Applicant : Lawrence D. Knox, et al.  
Serial No. : 10/629,243  
Filed : July 28, 2003  
Page : 15 of 26

Attorney's Docket No.: 02103-377003 / AABOSS14-  
CPCP

Amendments to the Drawings:

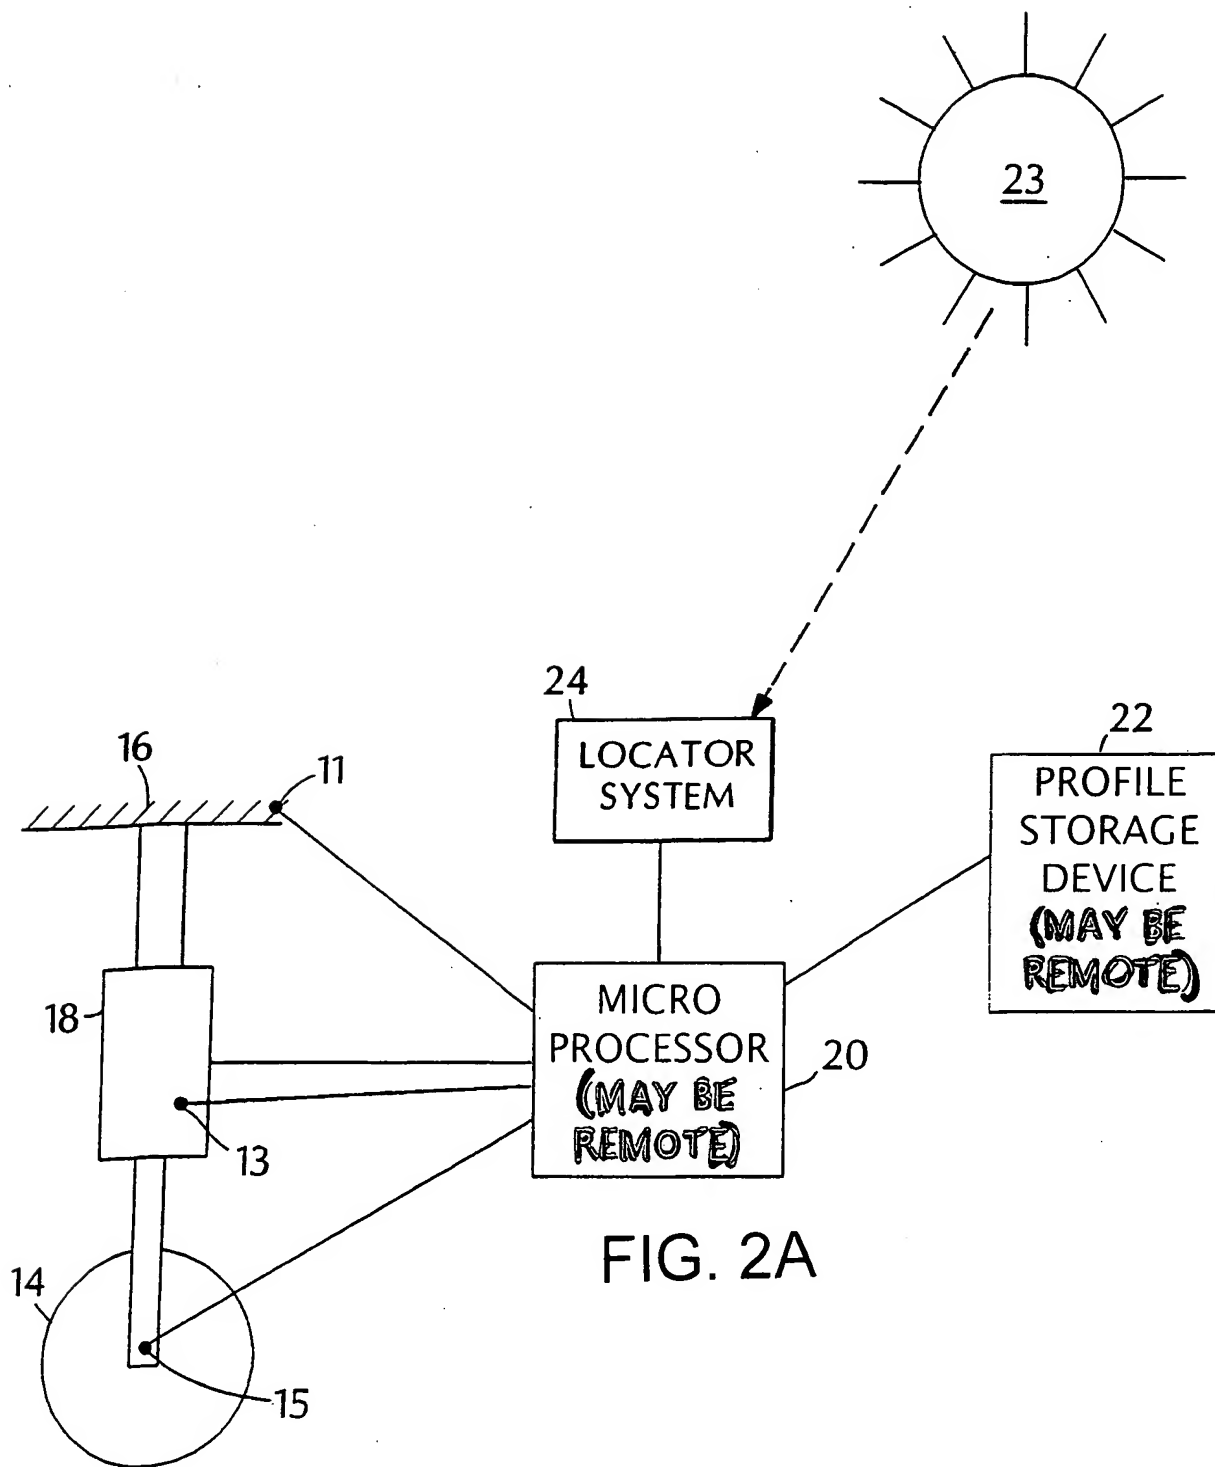
In Figure 2a, please insert "(MAY BE REMOTE)" in blocks 22 and 20.

**6. The drawings are objected to under 37 CFR 1.83(a). The drawings must show every feature of the invention specified in the claims. Therefore, the profile storage device and microprocessor remote from the surface vehicle (claims 2-3 and 21-22) must be shown or the feature(s) canceled from the claim(s). No new matter should be entered.**

(6.) Fig. 2a has been amended. At page 9, lines 21 – 28, it is indicated that the functions performed by microprocessor 20 may be performed by a number of microprocessors or

equivalent devices, some of which may be located remotely from vehicle 10 and that profile storage device 22 may be at some remote location.

FIG. 6A

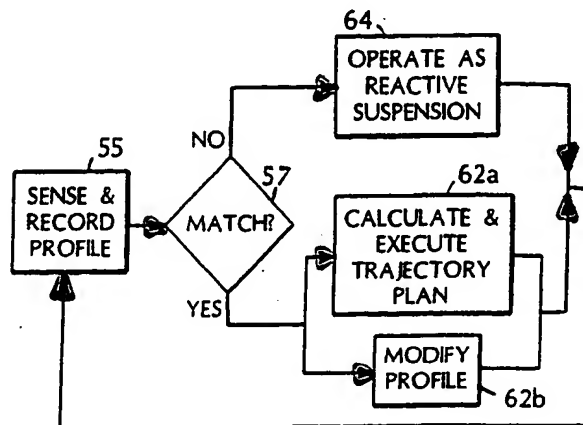
In Fig. 6a, please change "57" to "157".

In Figs. 6a, 6b, and 6c, please insert arrow heads as indicated.

g. Figures 6a-6c are unclear because there are no arrows on the lines showing the direction of flow.

**h. Contrary to page 15, lines 8-16 reference numeral 58 is not in Figure 6a (possibly, this should be reference numeral 57).**

(5g.) Figs. 6a – 6c have been amended to include arrows indicating the direction of process flow, consistent with the description of the process flow in the corresponding portion of the Specification.

(5h.) Reference numeral 57 in Fig. 6a and “58” at page line 9 have been replaced with “157”. The element indicated by reference numeral 157 in the Fig. 6a and the description of element 157 in the Specification are consistent.
